## The Strengthening Works on the funicular railway.

This post has been informed by comments made on my series of six posts on “Will the repairs to the funicular work” and discussion with people with a far greater knowledge of construction and civil engineering than me.

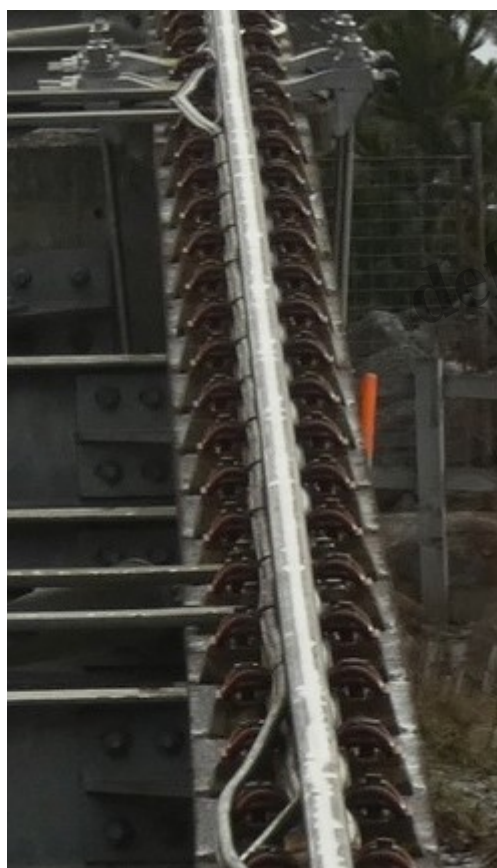
In my opinion there is now a new safety risk for inspectors and people working by the funicular which also shows poor work practices and that is the length of studding/ threaded bar, holding the brackets

together, protruding from (a) the sides and (b) up into the air.

(a) The excess steel-work protruding outwards from the brackets will hinder staff clearing snow away from the track and could cause injury, and,

(b) The extra lengths especially in the middle of the walkway, are a tripping hazard for staff working on it, from which someone could be seriously injured or even worse!

Why were the excess lengths not removed to make the work more presentable and safer?

Where are the safety markers that should be placed near those brackets? Even a coat of red paint would make them more obvious!

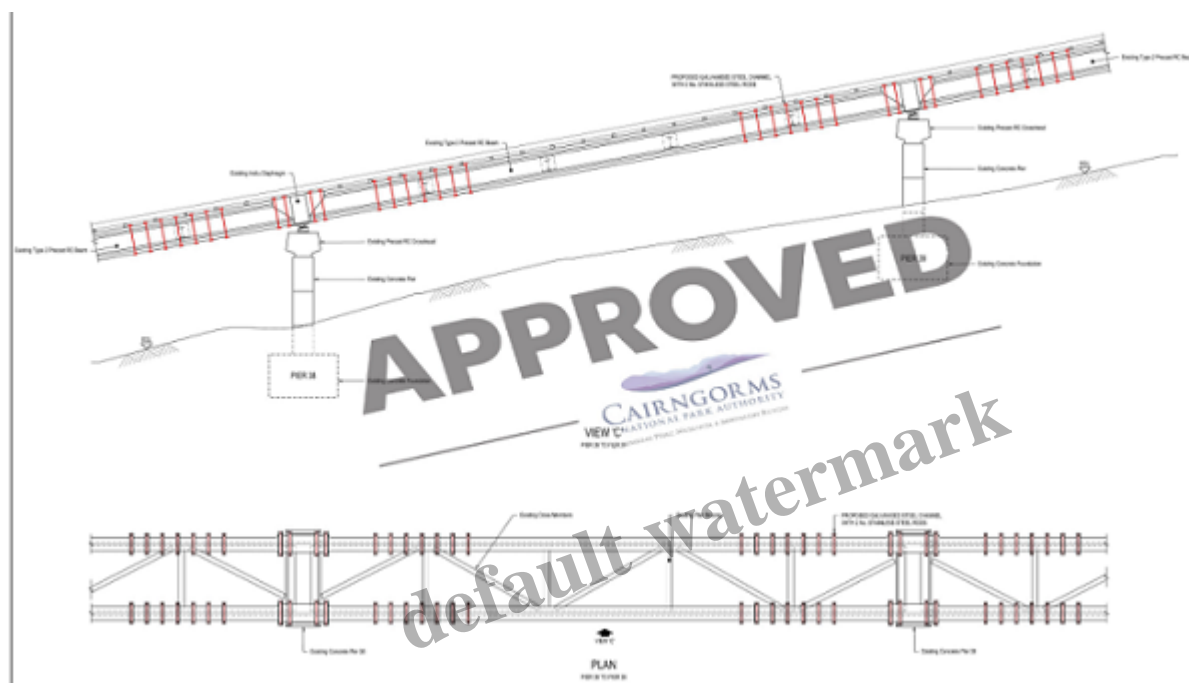
(4) The work is different to what was shown in the planning application

Note that the two brackets on the insitu blocks are not shown! A later addition?
